Model: Model A-P4	Date: 1-Jun-06	No.: RG147001b
-------------------	----------------	----------------

Subject: Firmware release note for A-P4 (BICU)		Prepared by: K.Takagi	
From: 1st Tech. Support Sec. Service Support Dept.			
Classification:	<input type="checkbox"/> Troubleshooting <input type="checkbox"/> Mechanical <input type="checkbox"/> Paper path <input type="checkbox"/> Product Safety	<input type="checkbox"/> Part information <input type="checkbox"/> Electrical <input type="checkbox"/> Transmit/receive <input checked="" type="checkbox"/> Other (      )	<input type="checkbox"/> Action required <input type="checkbox"/> Service manual revision <input type="checkbox"/> Retrofit information

Subject: Firmware release note for A-P4 (System)		Prepared by: K. Takagi	
From: 1st Tech. Support Sec. Service Support Dept.			
Classification:	<input type="checkbox"/> Troubleshooting	<input type="checkbox"/> Part information	<input type="checkbox"/> Action required
	<input type="checkbox"/> Mechanical	<input type="checkbox"/> Electrical	<input type="checkbox"/> Service manual revision
	<input type="checkbox"/> Paper path	<input type="checkbox"/> Transmit/receive	<input type="checkbox"/> R

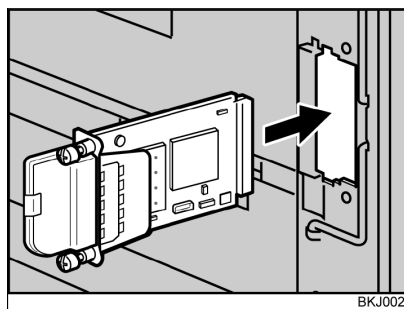
Previous types:  
PCB, LAN card, and cover are  
separate

New Type (IEEE802.11b  
Interface Unit Type N):  
Pre-assembled
